Supplement to March 1, 1984
Proposed Administrative Technical
Specification Change

Proposed Changed Pages

Figure 6.2-2 Facility Organization

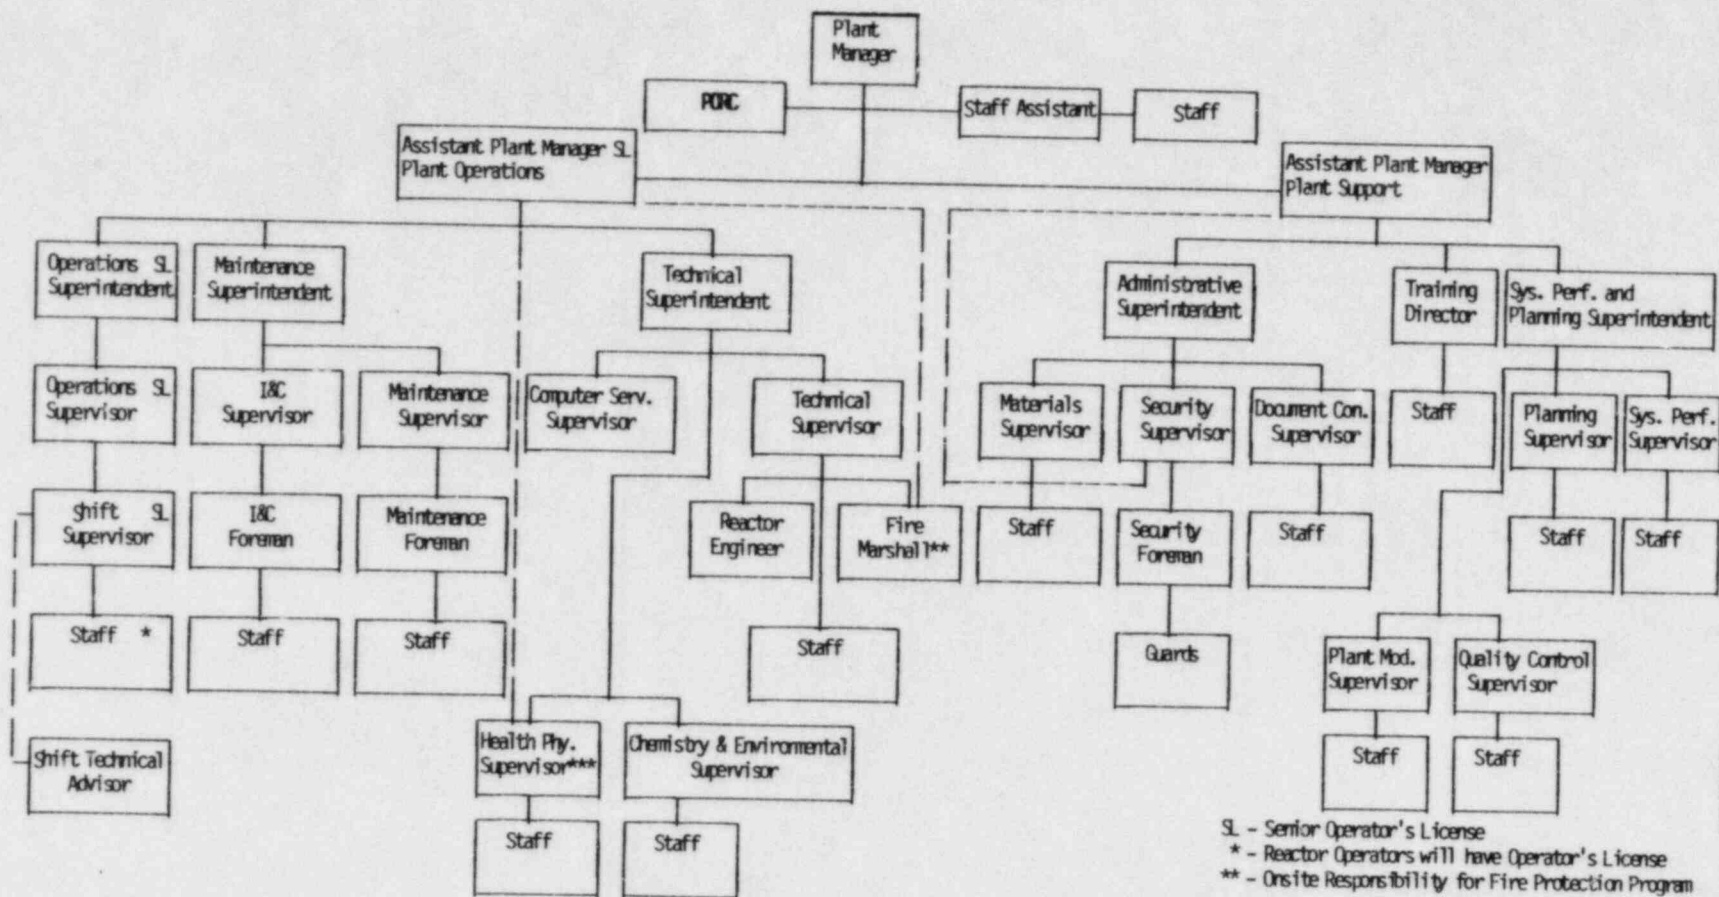
*** In routine matters, the Health Physics Supervisor reports directly to the Technical Superintendent, in matters of radiation policy determination, interpretation or implementation (Based upon the Health Physics Supervisor's judgment) the Health Physics Supervisor may report directly to the Assistant Plant Manager.
